Ecological Advice Note: Lighting Strategy Review – Embassy Village, Manchester

Document Reference:	11530.001
Date:	05/01/2026
Author:	JC
Approved:	RW

- 1.1 The Environment Partnership (TEP) were commissioned, by Embassy Village in December 2025, to provide an Ecological Advice Note reviewing the lighting layout to discharge condition 11 b) of a planning application to Manchester City Council (Planning ref: 137608/JO/2023) for the development of 40 new high quality modular homes for homeless men and associated infrastructure at Embassy Village, Bridgewater Canal, Hulme Lock Branch Canal And Egerton Street, Manchester, M15 4JS (central grid ref: SJ 82719 97479).

Figure 1: Installed light within archway (left), Height to installed light in archway from ground (right)

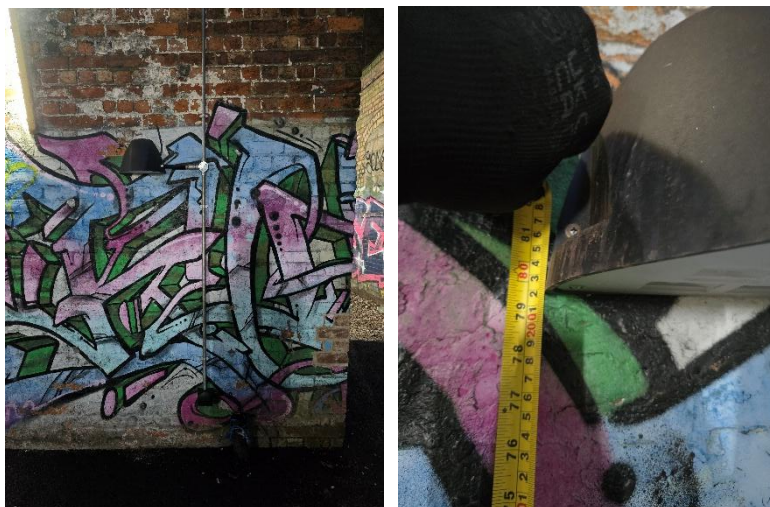
- 1.10 Lights within archways have been installed at a height of 2.1-2.2 m (e.g., Figures 1 and 2). The lighting types installed in these locations all comprise lights which are directional in design with solid covers which prevent light spill above the position of the light, as shown in the data

sheets submitted with the application to discharge condition 11a). This ensures that bat roost features positioned above this height will not be significantly impacted by light.
